HILLARYS MARINA

**Location of proposed development.
Lot 9009 (35) Martinique Mews, Hillarys**

Ground Floor Plan - with perspective viewpoints
Harbour Rise Mixed Use Development

41737
DA02-E

PERSPECTIVE VIEW - 02
HILLARY HARBOUR RISE MIXED USE

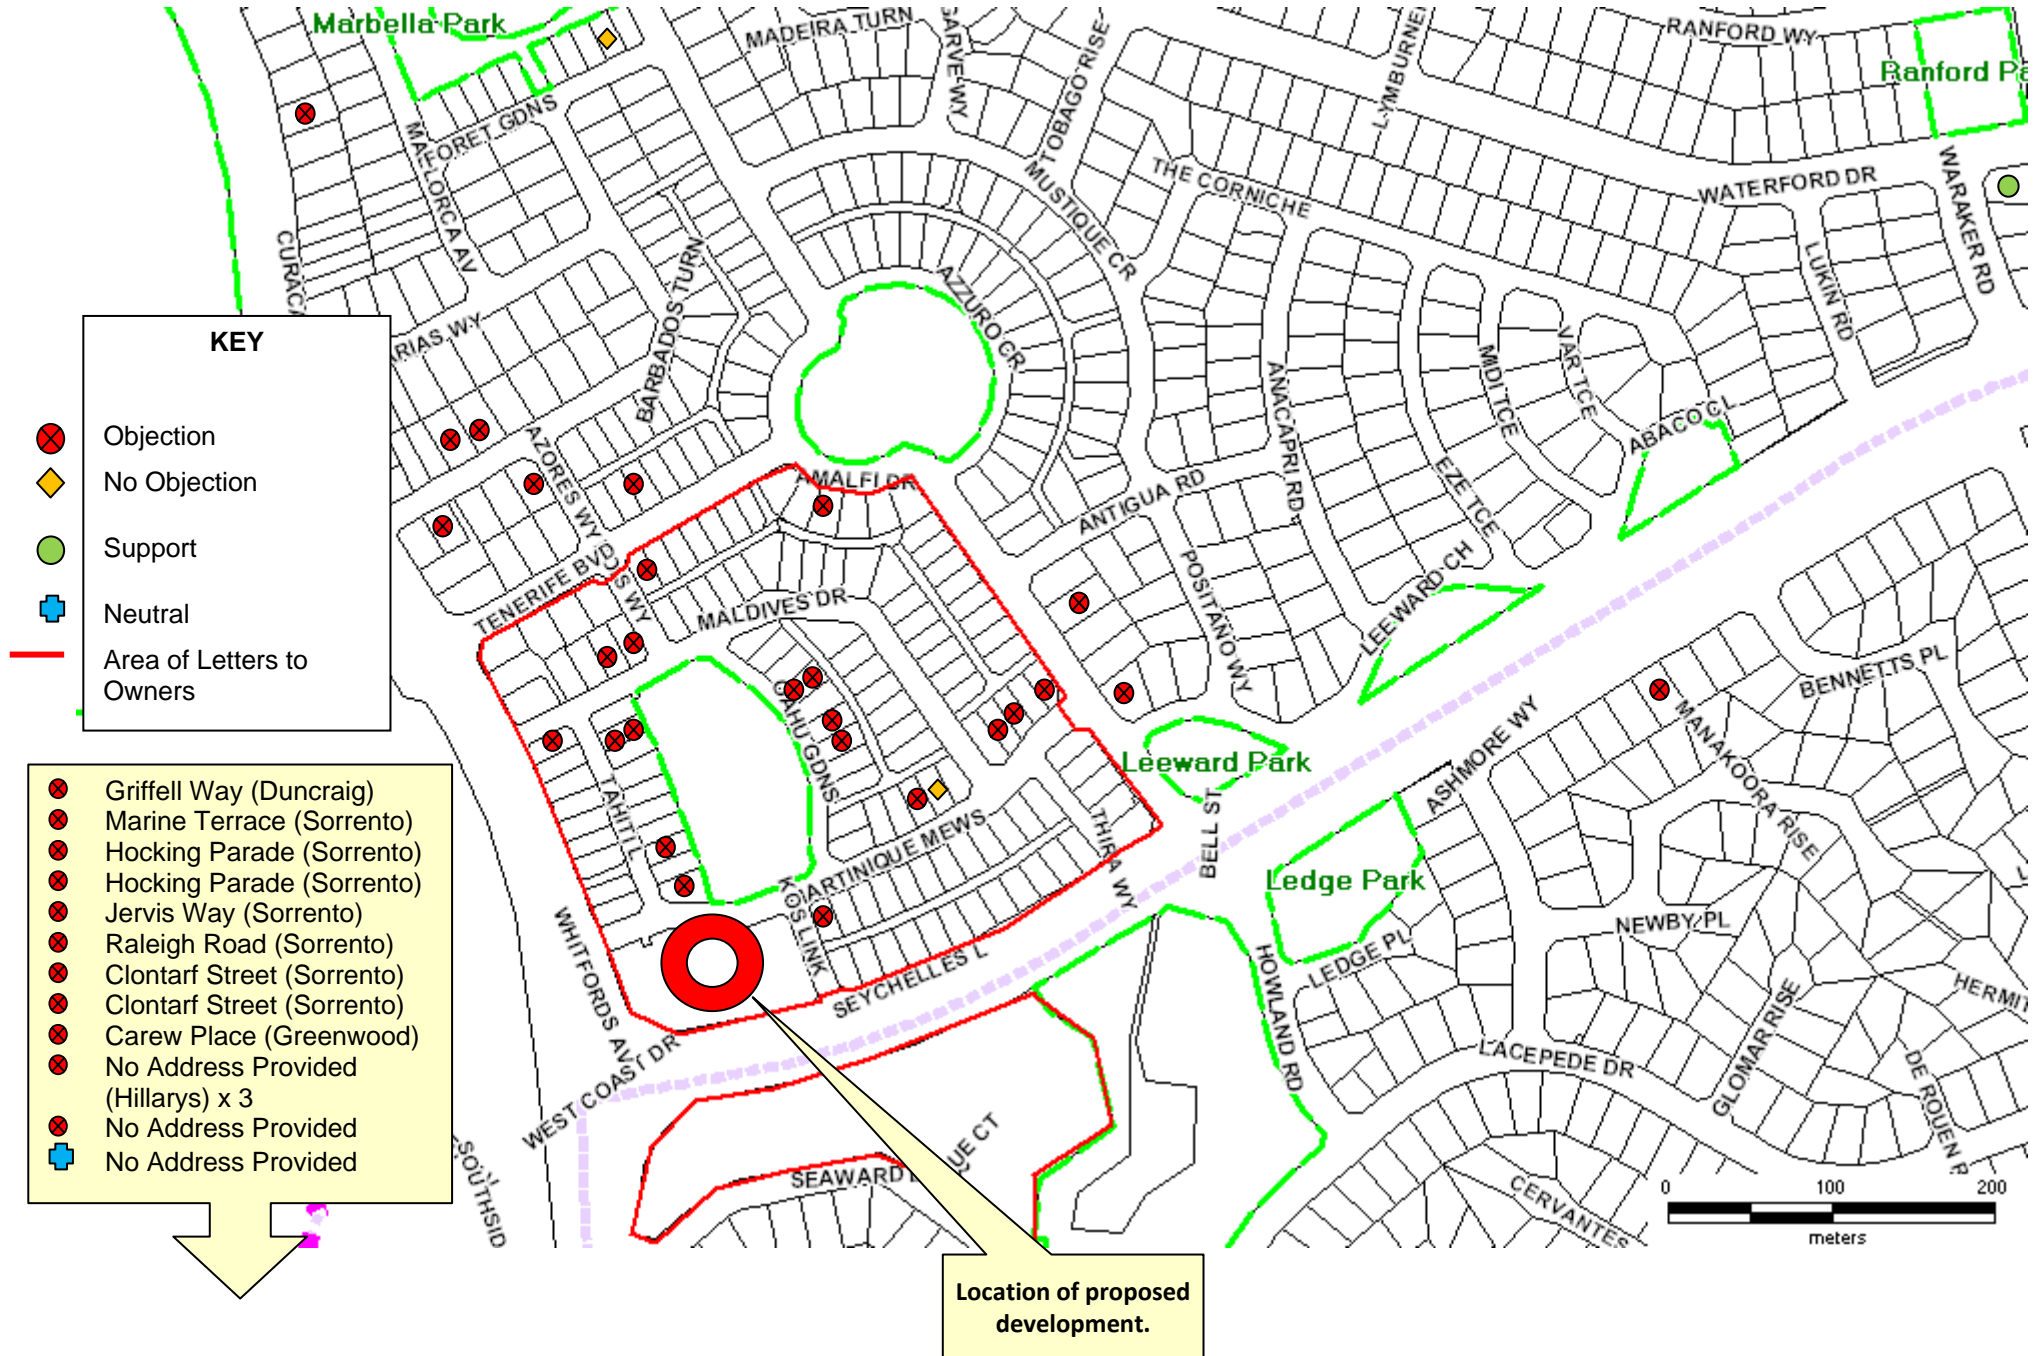
Comment Received	City's Comment
<ul style="list-style-type: none"> • The Building Height exceeds the City's Coastal Height Policy. It is important that this height limit is maintained; • We have already seen the Council over-ride this policy in respect to the Sacred Heart development. This will corrupt wonderful beach front areas which we have an obligation to preserve for future generations; • We had height limitations imposed on our dwelling being 9.5m ridge height and 12.5 metres if we had a 3mx3m tower; • The three storey development will also take a lot of views from current residents; • The proposed three stories and bulk of the development will detract from the surrounding Residential amenity; • Two storey dwellings with a loft is far better option as it will blend in better with surroundings; and • The Structure Plan envisaged that only the corner of Hepburn and Whitfords Avenues be a "Landmark" up to three storeys. With approximately half the site being devoted to three storeys clearly it does not comply with this requirement. 	<ul style="list-style-type: none"> • Council is required to have due regard to Policy 3-4 and its objectives when determining this application. • A three storey development is permitted where Council considers that a quality landmark is achieved. The overall height of the development as measured from natural ground level is consistent with the ridge height permitted for a single house with a tower element in the surrounding Structure Plan area (12.5 metres).

<ul style="list-style-type: none"> • The scale of the development is inconsistent with surrounding residential development and the objective of the mixed use zone to permit low impact non residential land uses compatible with the maintenance of residential amenity; • The site is bounded to the north and east by a substantial small lot residential precinct; and • The proposed development exceeds the permitted density coding. 	<ul style="list-style-type: none"> • The site has a density coding of R50 under the Structure Plan and DPS2 and as such is intended to be of a higher density than the surrounding residential development. • No variations are being sought in relation to density, plot ratio, or the total amount of floor space permitted for the non-residential land uses.
<ul style="list-style-type: none"> • The building does not deliver the landmark the City wants as it diverts all commercial activity away from the Hepburn/Whitfords Avenue Roundabout and does not deliver active street frontages or pedestrian amenity required by the Structure Plan. 	<ul style="list-style-type: none"> • The mix of facades, colours and materials and the level of articulation of the proposed buildings is considered to be a landmark quality development. • The proposed commercial development has been situated within the site to allow high levels of pedestrian access and interaction. This also allows for passive surveillance from the outdoor living areas of the ground floor multiple dwellings to prevent or deter antisocial behaviour.
